# UNITED STATES PATENT AND TRADEMARK OFFICE

APPLICATION NO.	FILING DATE	FIRST NAMED INVENTOR	ATTORNEY DOCKET NO.	CONFIRMATION NO.
10/662,579	09/15/2003	Kenneth M. Spink	02-ASD-184 (GT)	9319

**Office Action Summary**

## **DETAILED ACTION**

Fig. 2

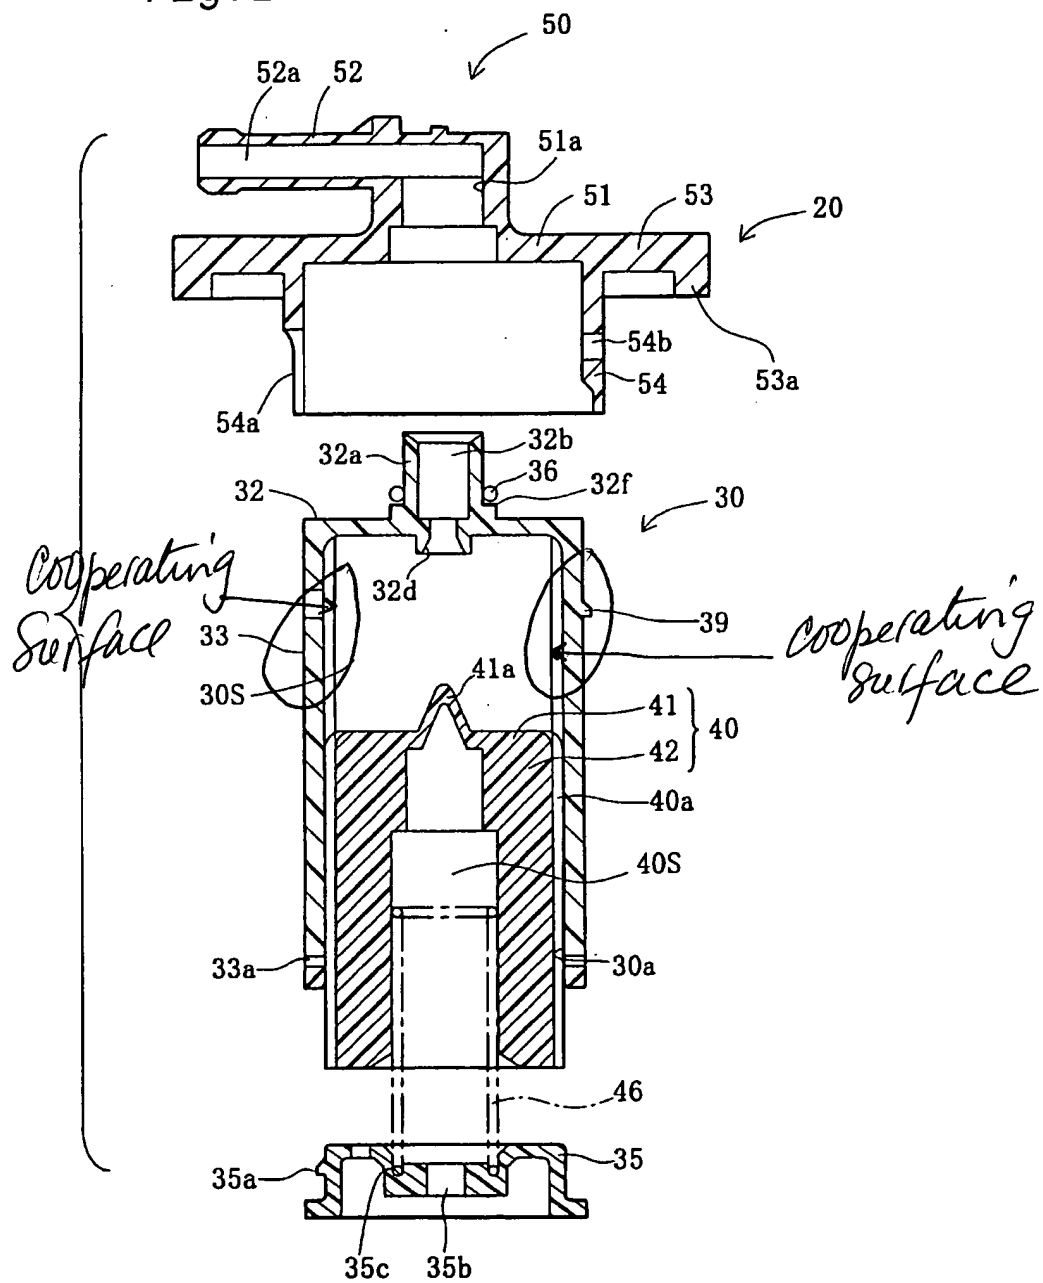
In response to Applicant's argument that "nothing in Aoki suggests engaging cooperating surfaces that prevent relative rotation between the float and the float chamber", the examiner respectfully disagrees. In column 5, lines 18-20, Aoki states that "A guide rib 40a is formed along the outside periphery of the float 40 and is **guided** by an inside wall of the casing", this clearly suggests a "guiding groove" that can clearly be seen in figures 1 and 2: as float 40 is introduced in casing 30, guide ribs 40a are seen engaging cooperating slots or grooves (see the encircled and marked portions of the attached figure), and this engagement will prevent the float from rotating within the float chamber.

In view of the above remarks, the examiner maintains that a *prima facie* case of obviousness has been established in the instant application as outlined in the above rejections.
